RE: REQUEST FOR MINOR CHANGE TO EXISTING APPROVAL IN ACCORDANCE WITH S81 OF THE PLANNING ACT 2016 – MATERIAL CHANGE OF USE FOR MULTIPLE DWELLING DEVELOPMENT (A003859713) UPON LAND LOCATED AT 255 BEENLEIGH ROAD, SUNNYBANK AND 29 FOWEY STREET, SUNNYBANK.

MINOR CHANGE APPLICATION

Figure 4: Proposed Site Plan.

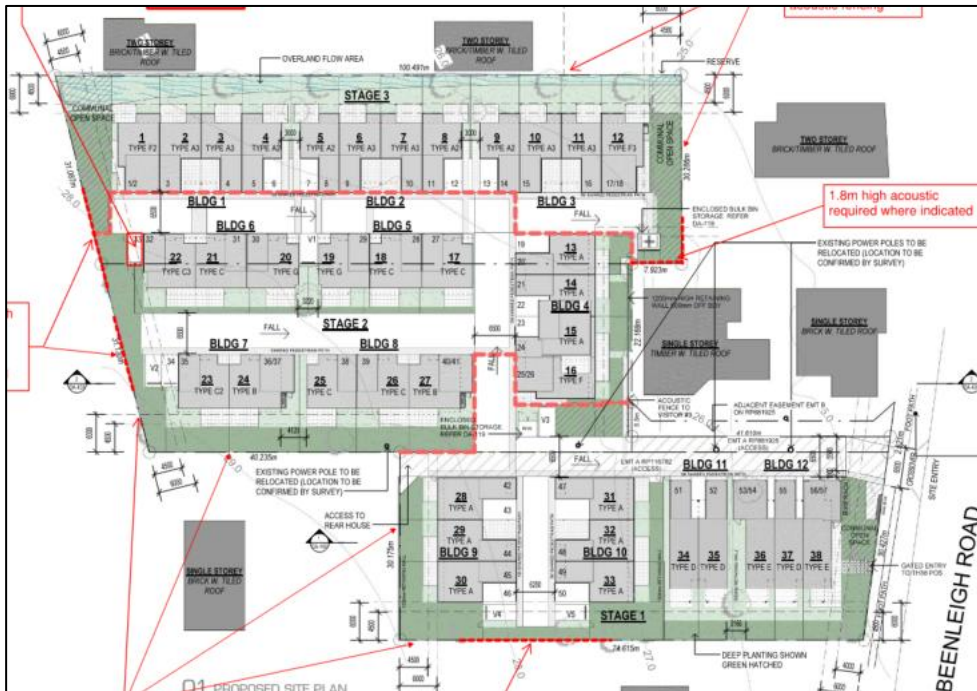
The following section outlines the nature of the proposed minor changes, supported by updated architectural and site plans (refer to Figures 3–6). Each aspect of the minor change is discussed in turn, with specific attention to consistency with the approved development, relevant performance outcomes, and the extent of variation from the approval. The discussion demonstrates that the proposed changes are limited in scope, do not alter the intent or function of the approved development, and continue to achieve the relevant assessment benchmarks. As Stage 1 has been completed, the scope of the work(s) omits Units 28-38.

The proposed development continues to provide for 38 residential units and does not involve any alteration to critical site dimensions, dedications, reserves, or the overall site layout. The approved building footprint and siting remain consistent with the existing approval.

Some minor refinements have been made through the detailed design process and preparation of finalised plans. These refinements result in alterations to courtyard and balcony widths and a slight update to reflect the requirements around design elements associated with the building approval (e.g. Hot water system allocations etc and internal floor to ceiling heights). The roof form has been modified to maintain compliance. Importantly, these variations maintain suitability with the applicable benchmarks and ensure the overall outcomes of the approval are not compromised.

Figure 6: Proposed Roof Plan (Stages 2 & 3).

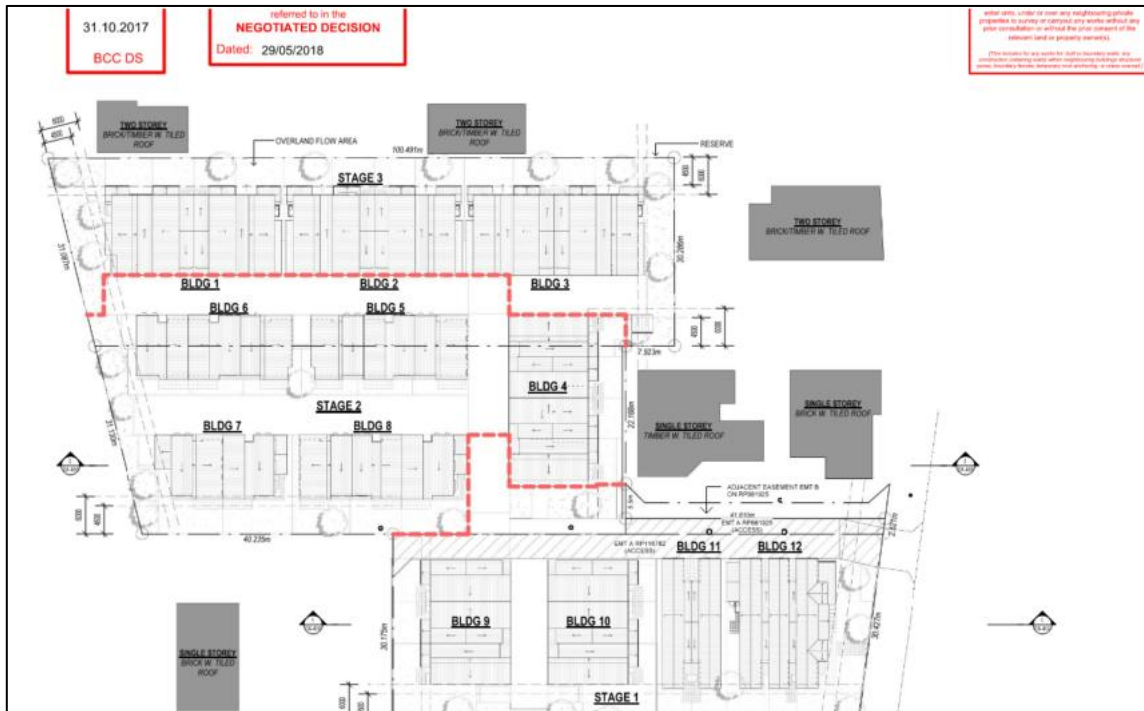
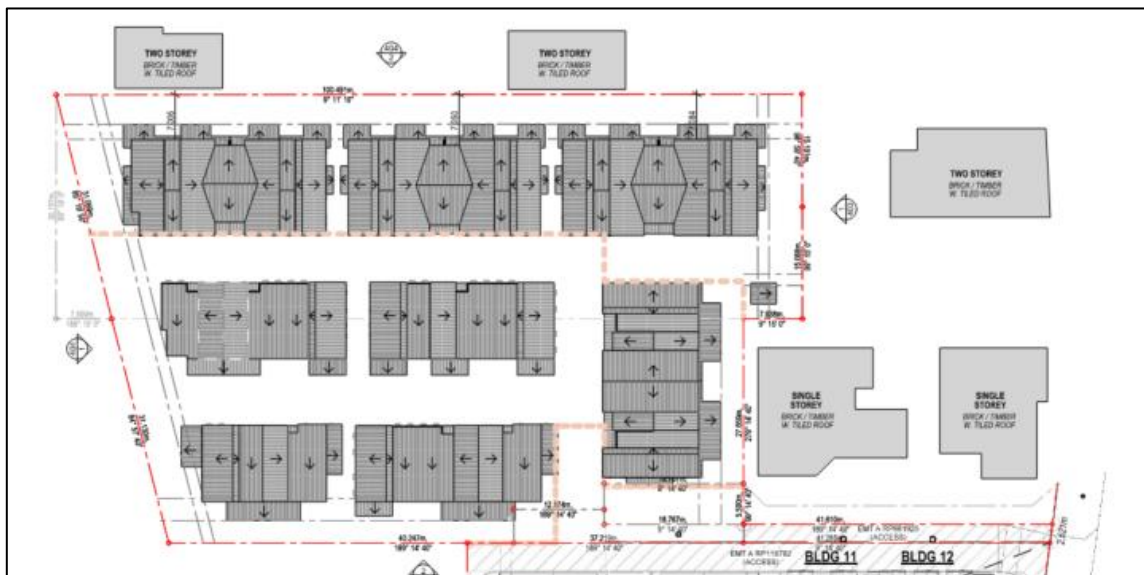
As seen in Figures 5 and 6 the proposed roof forms have changed slightly to reflect a more effective delivery during construction and enable improved floor to ceiling heights, without disrupting overall building heights. The revised roof plan simplifies and standardises the roof layout across the development, compared to the 2018 approved plan, the updated design reduces the number of roof breaks and step-downs, aligns ridgelines more consistently between adjoining dwellings, and consolidates roof planes into clearer, continuous sections. These adjustments improve roof drainage, simplify construction, and provide greater aesthetic cohesion between buildings.
